Service Bulletin

NO:HIFI2-01-010

SUBJECT: Unit May Shut Off With A Slight Shock

MODEL (S): MZ-R55

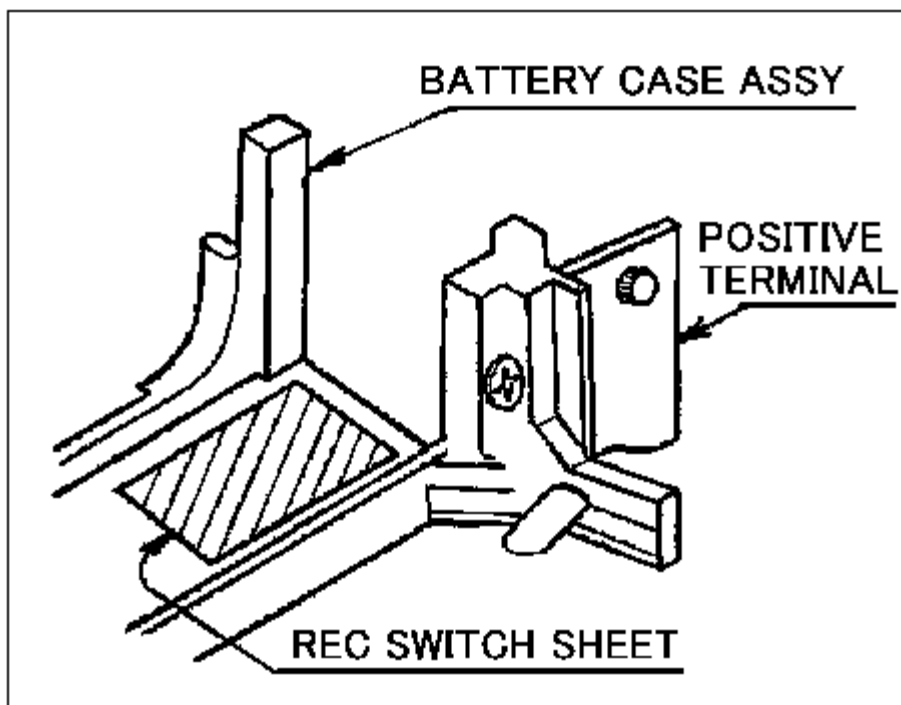
Symptom: Unit may shut off with a slight shock when using Rechargeable Battery.

1. Replace BATTERY CASE ASSY with a new one.
2. Add REC SWITCH SHEET to the Battery Case Assy as Figure.

Description	Part Number
SHEET, REC SWITCH	3-303-838-03
